Subject: Fuel Leak Case No. RO0002525, Shell#13-5440, 318 South Livermore Avenue, Livermore, CA

Alameda County Environmental Health (ACEH) staff has reviewed the case file and the documents entitled, "Soil and Groundwater Investigation and Over-Excavation Report," dated July 11, 2005, and "Quarterly Monitoring Report – Second Quarter 2005," dated June 10, 2005. Both reports were prepared on behalf of Shell by Delta Environmental Consultants, Inc. The "Soil and Groundwater Investigation and Over-Excavation" report presents the results from three soil borings drilled in June 2005 and overexcavation of fill material containing elevated concentrations of lead. The report includes recommendations for over-excavation of soil in the central portion of the site and additional investigation potholes to define the extent of lead in fill materials in the southern portion of the site. The report also includes a recommendation to install an additional monitoring well between existing wells MW-7 and MW-8. ACEH concurs with the recommendations provided that the conditions identified in the technical comments below are met.

Subject: Fuel Leak Case No. RO0002525, Shell #13-5440, Former Service St

<sup>1</sup> Hydrographs for Zone 7 Water Agency shallow-zone observation wells 3S/2E 8K2, 3S/2E 16E 4, and 3S/2E 9Q 4 are attached.

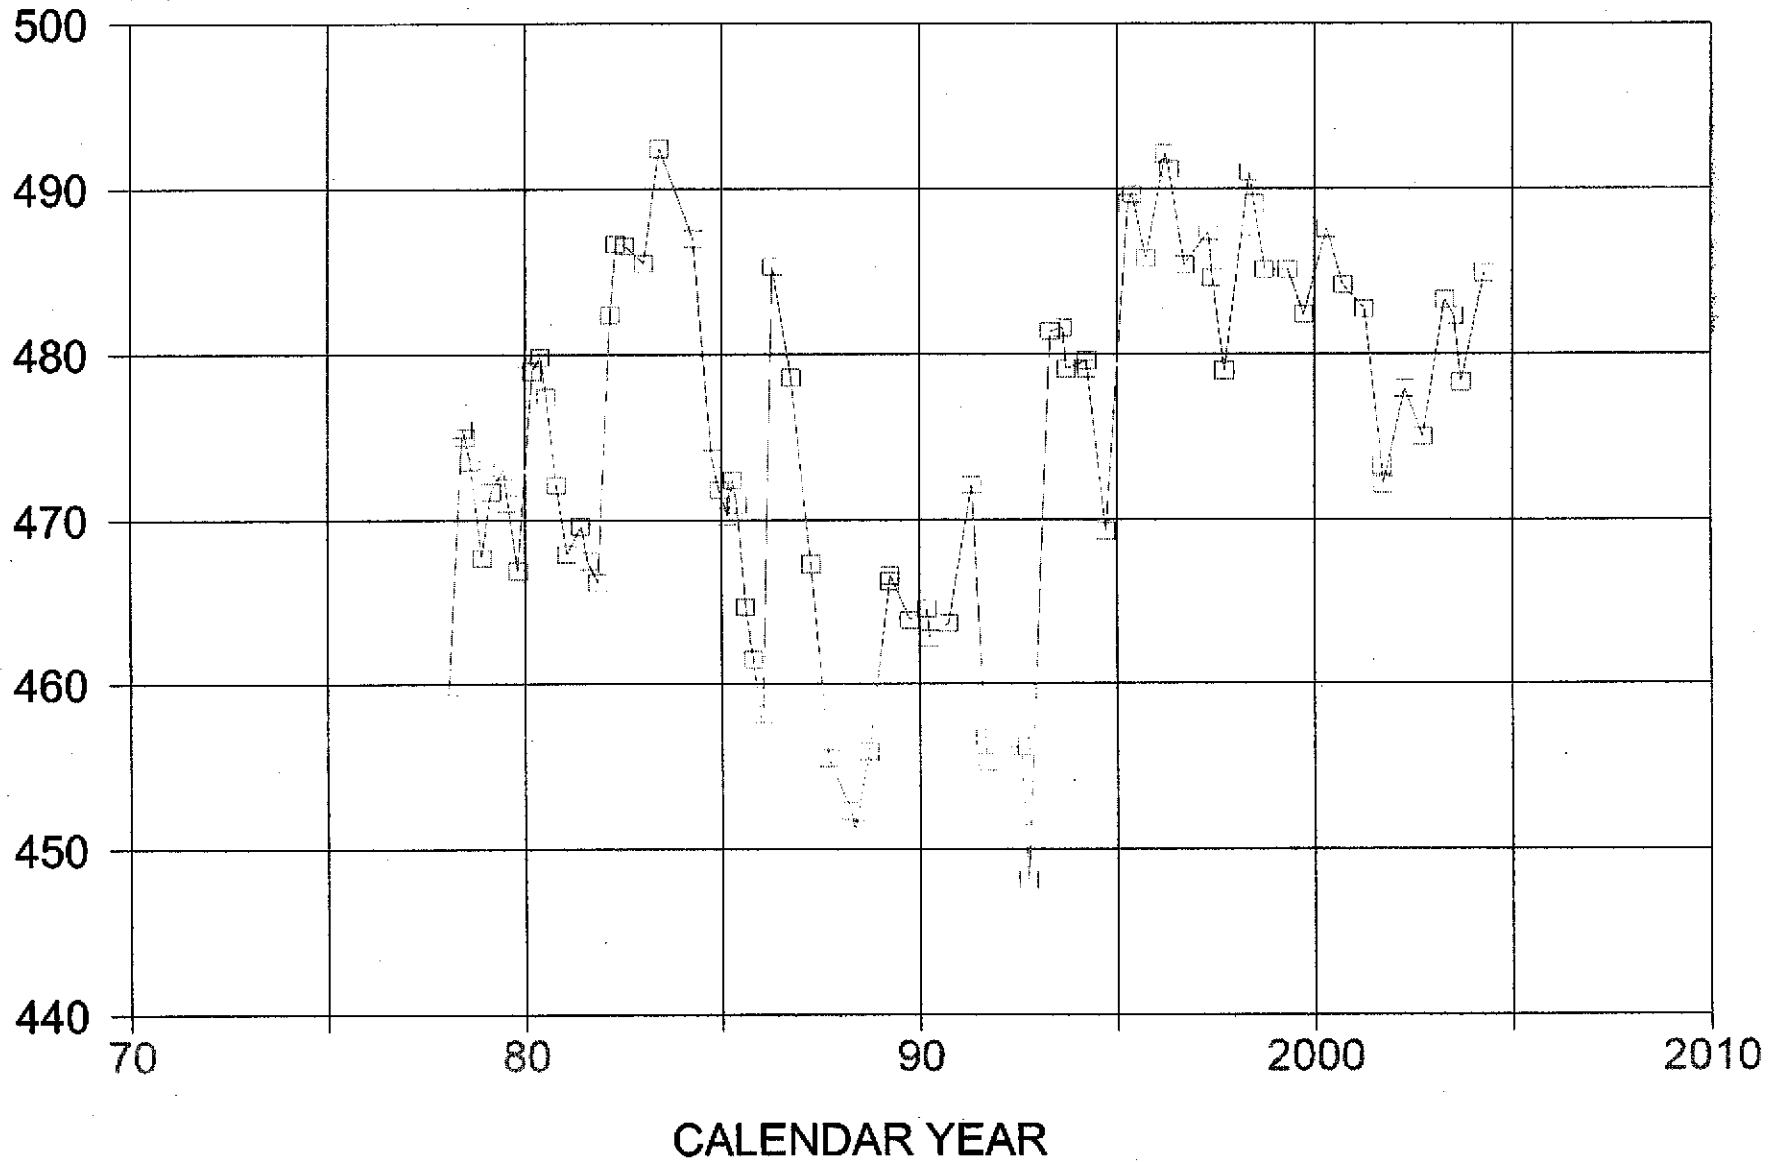
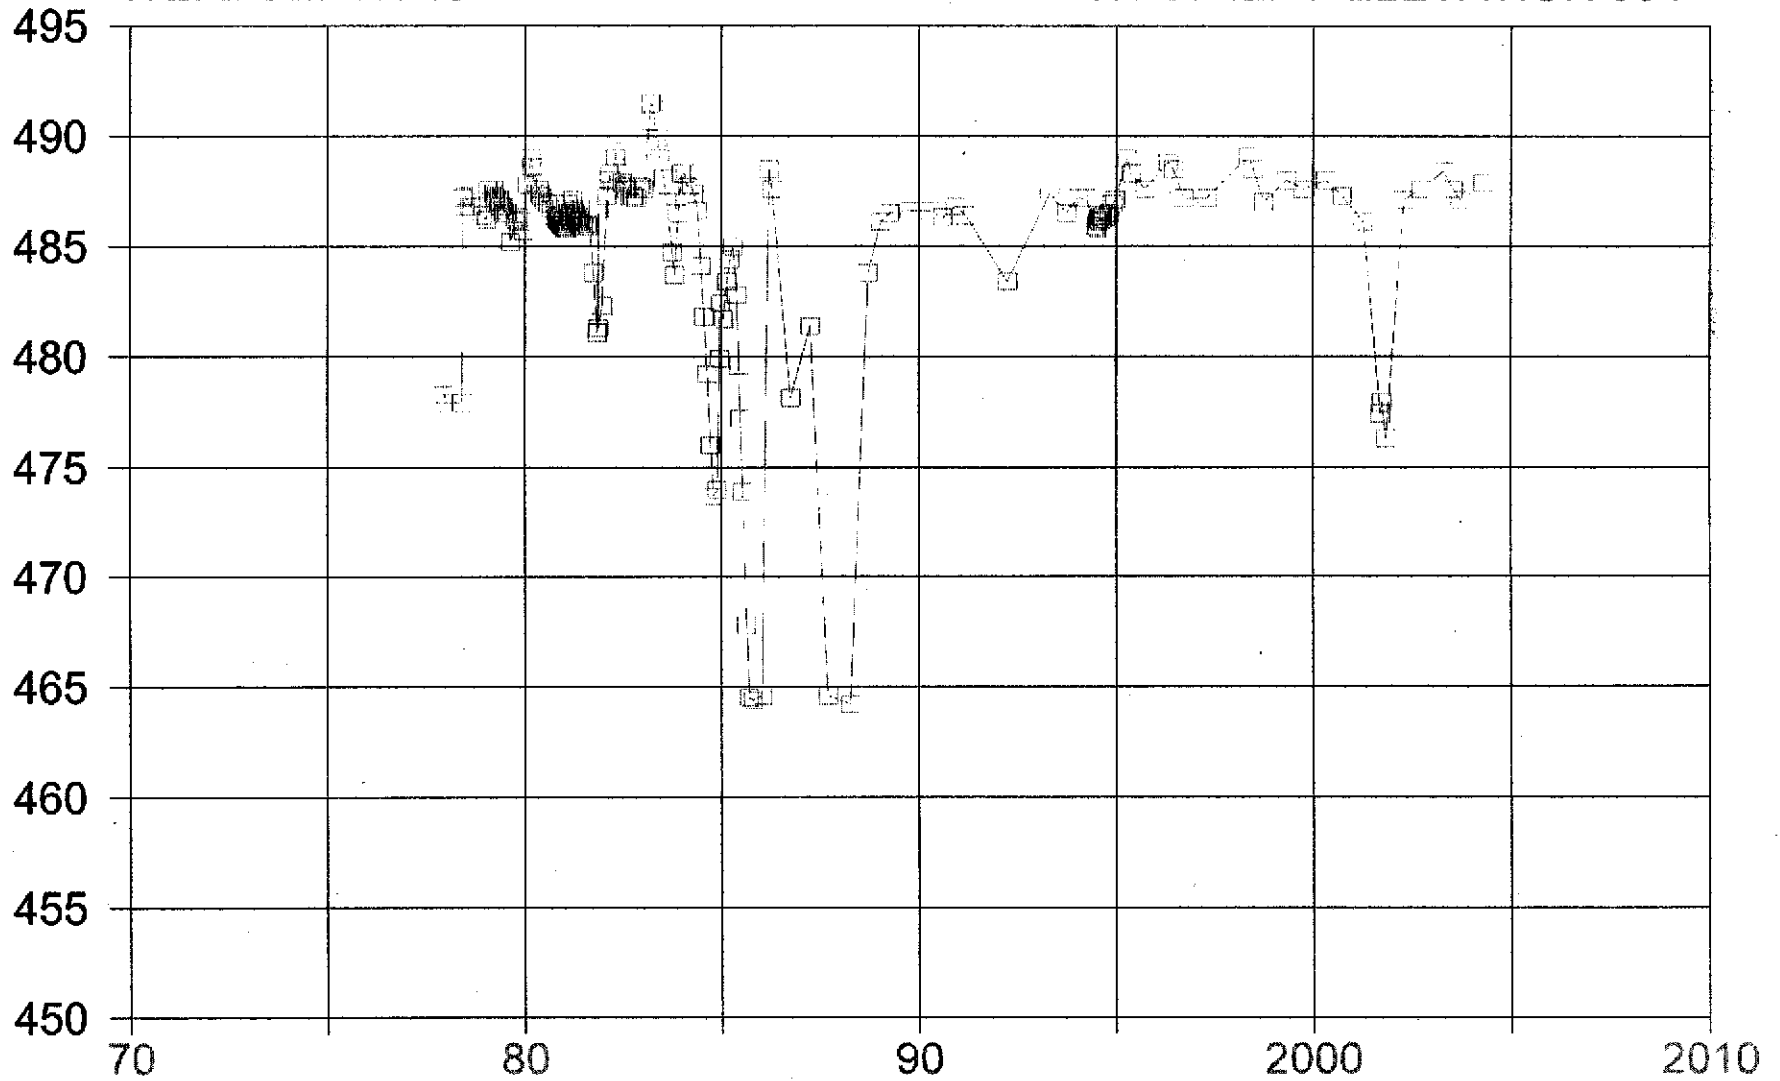
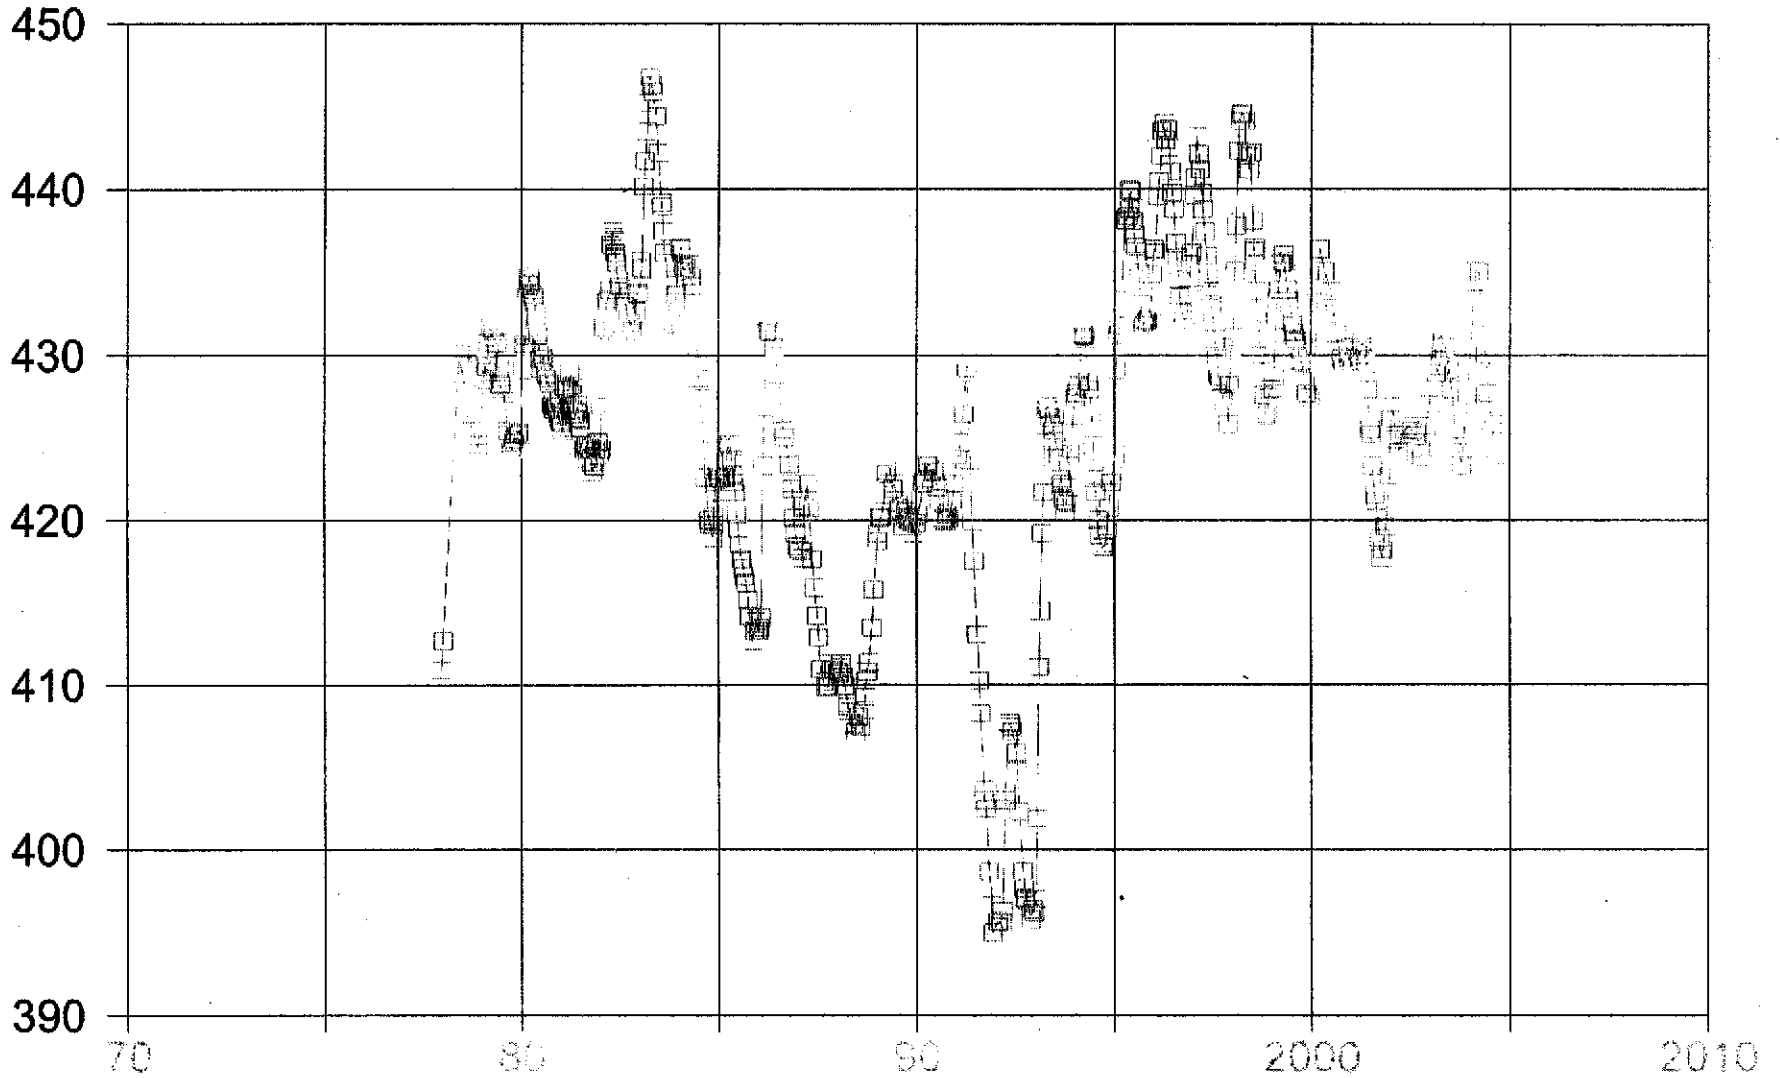
Due to historical groundwater elevation fluctuations, additional vertical definition is also necessary. No groundwater elevation data is available for the site prior to 1989 or for the period between 1995 and 2001. However, the relative groundwater elevation trends (rising or falling)

for the site appear to correlate well with the regional data<sup>1</sup>. Continuous regional groundwater elevation data is available from the late 1970s through the present, and historical site groundwater elevations can be inferred from the regional data set.
